JAMES A. FITZPATRICK NUCLEAR POWER PLANT

AMENDED FACILITY OPERATING LICENSE

Amendment No. 22
License No. DPR-59

ATTACHMENT TO LICENSE AMENDMENT NO. 22

Figure 6.1-1

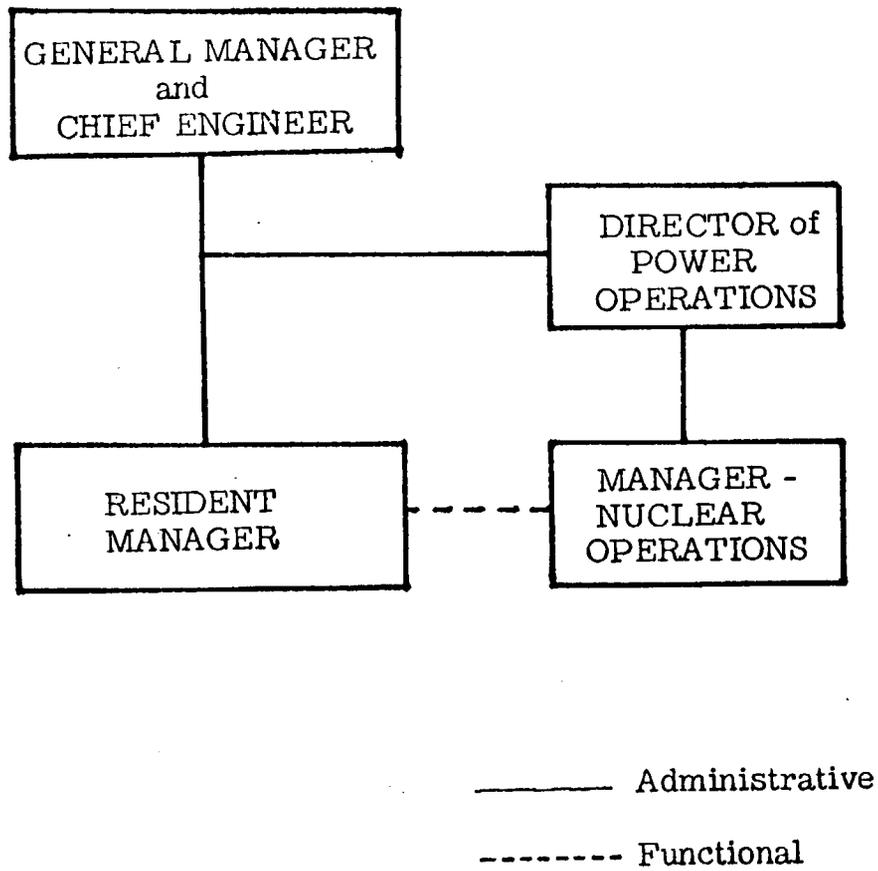
The Resident Manager is responsible for safe operation of the plant. During periods when the Resident Manager is unavailable, the Superintendent of Power will assume his responsibilities. In the event both are unavailable, the Resident Manager may delegate this responsibility to other qualified supervisory personnel. The Resident Manager reports directly to the General Manager and Chief Engineer for administrative matters and functionally to the Manager - Nuclear Operations for operational related matters, as shown in Fig. 6.1-1.

Figure 6. 2-1

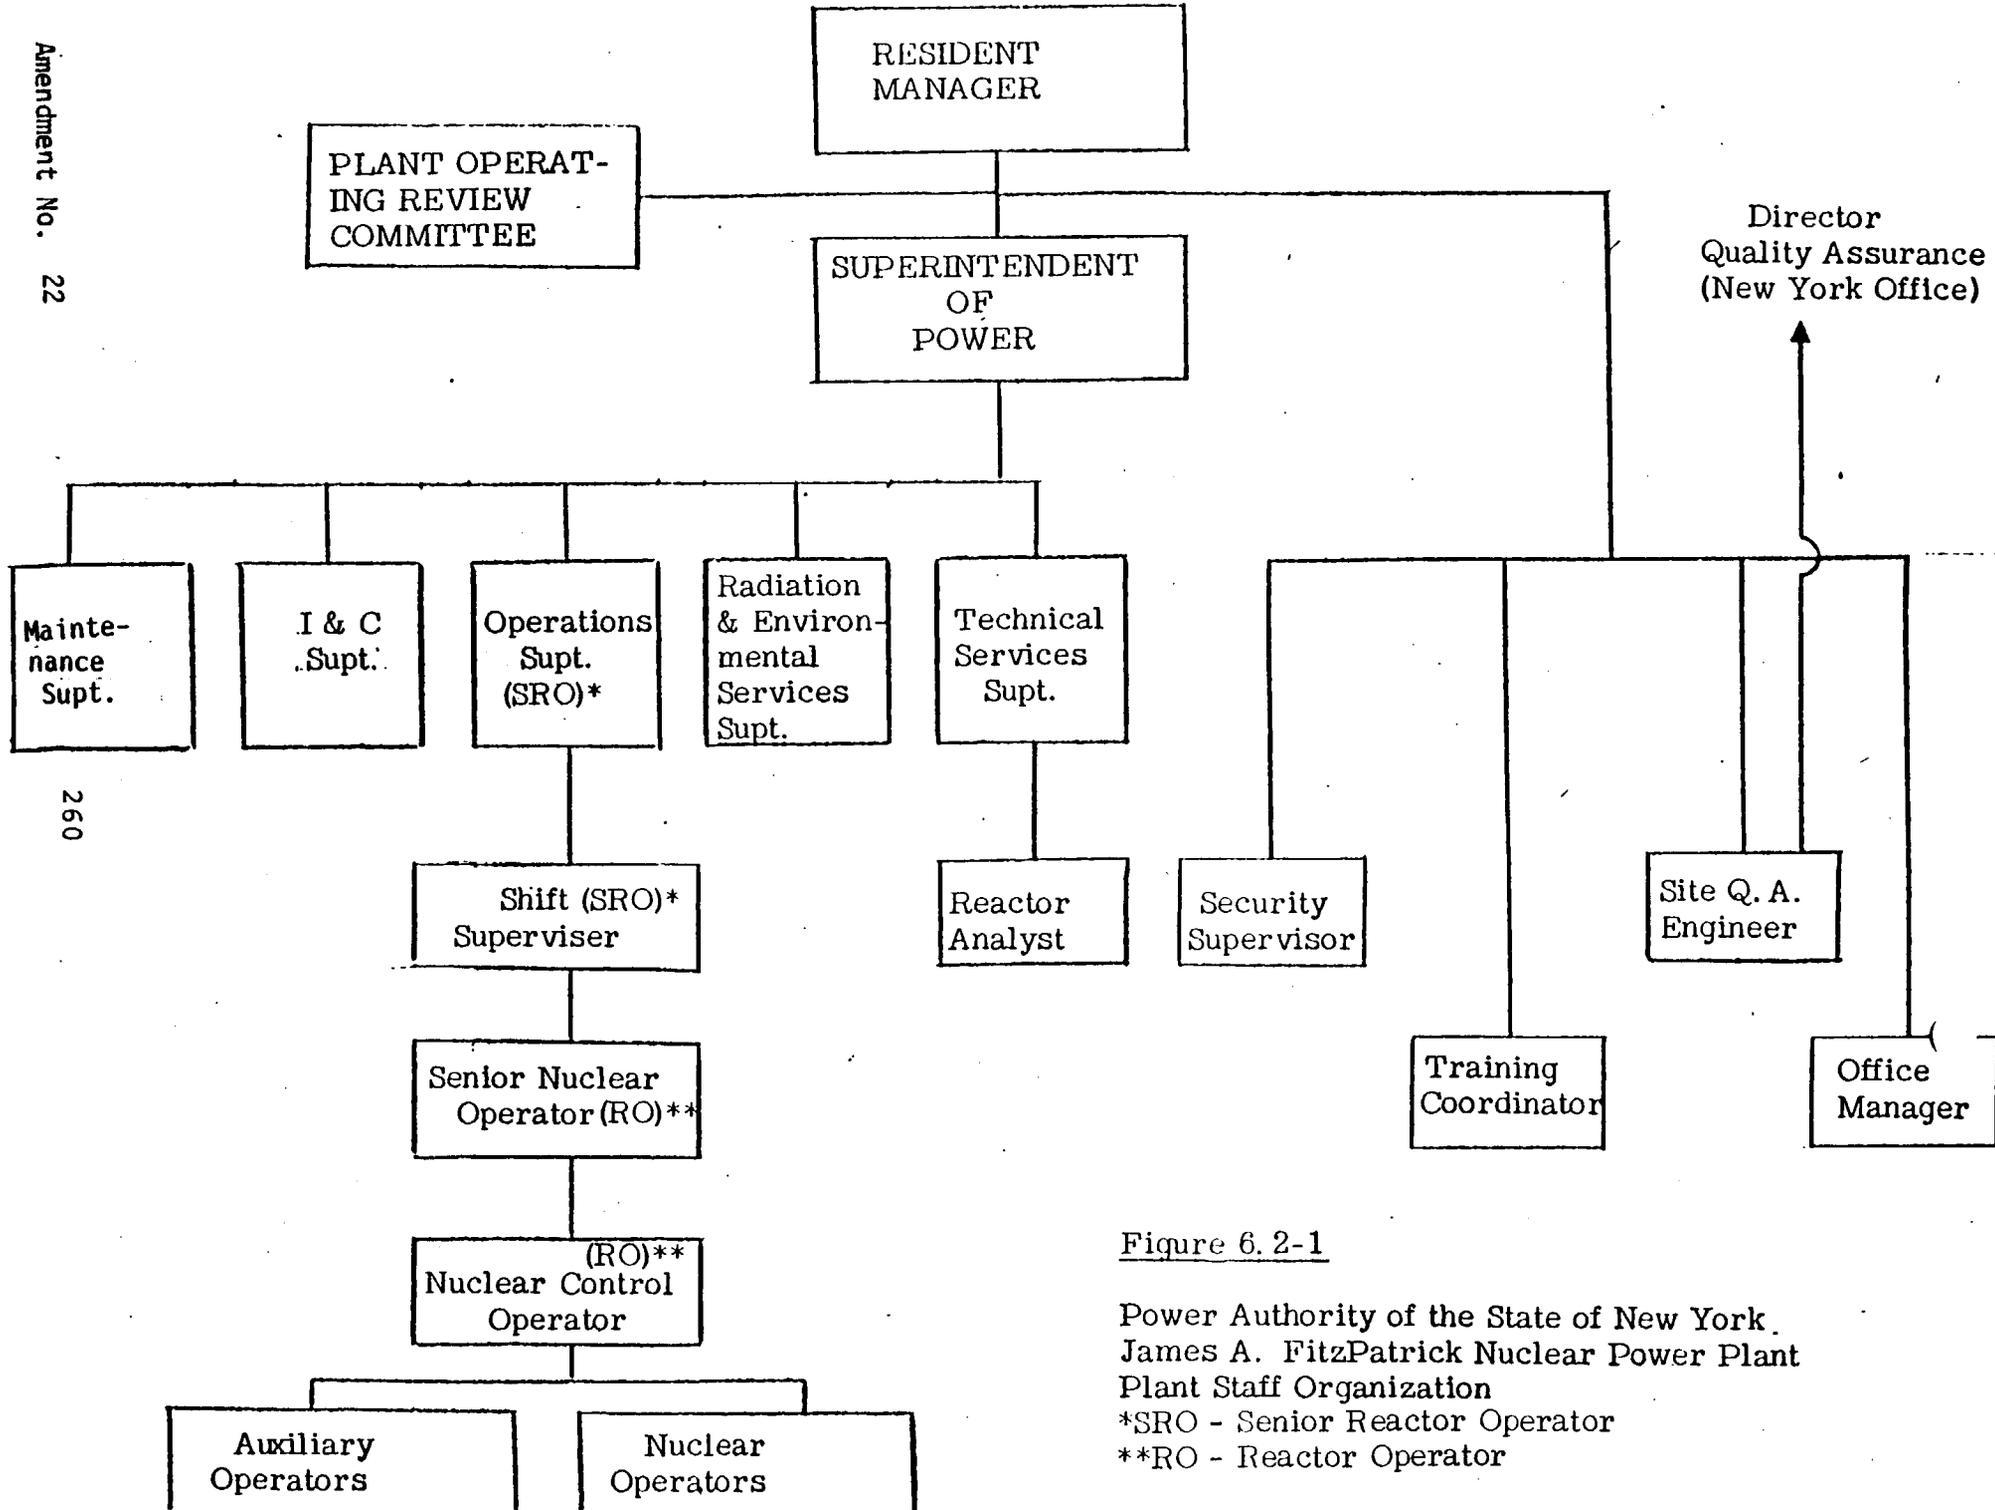
The plant staff organization is shown graphically in Fig. 6.2-1 and functions as follows:

The minimum qualifications with regard to educational background and experience for plant staff positions shown in Fig. 6.2-1 shall meet or exceed the minimum qualifications of ANSI N18.1-1971 for comparable positions, except for the Radiation and Environmental Services Superintendent who shall meet or exceed the qualifications of Regulatory Guide 1.8, September 1975. Any deviations will be justified to the NRC prior to an individual's filling of one of these positions.

FIGURE 5.2-1
POWER AUTHORITY OF THE STATE OF NEW YORK
JAMES A. FITZPATRICK NUCLEAR POWER PLANT
PLANT ORGANIZATION - ENVIRONMENTAL

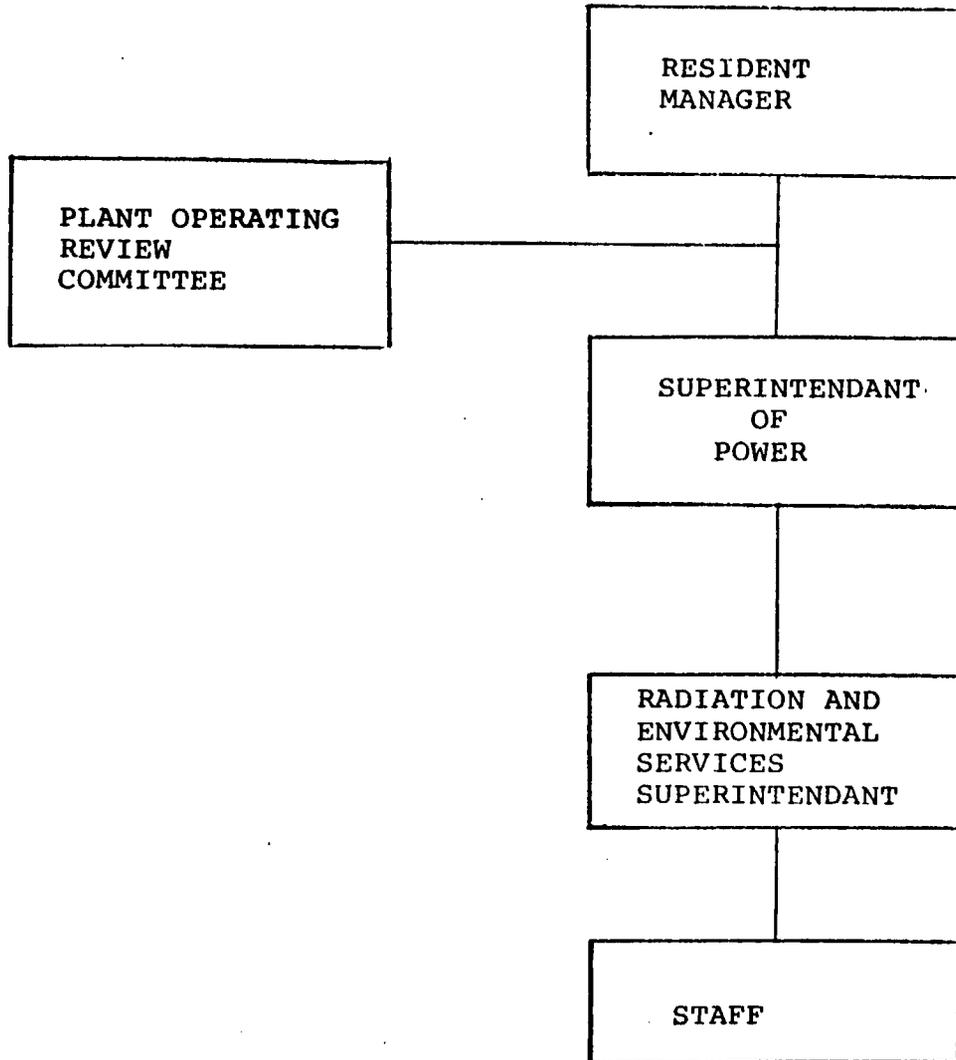
Organization relative to environmental matters at the plant and headquarters' levels are presented in Figures 5.2-1 and 5.2-2 respectively.
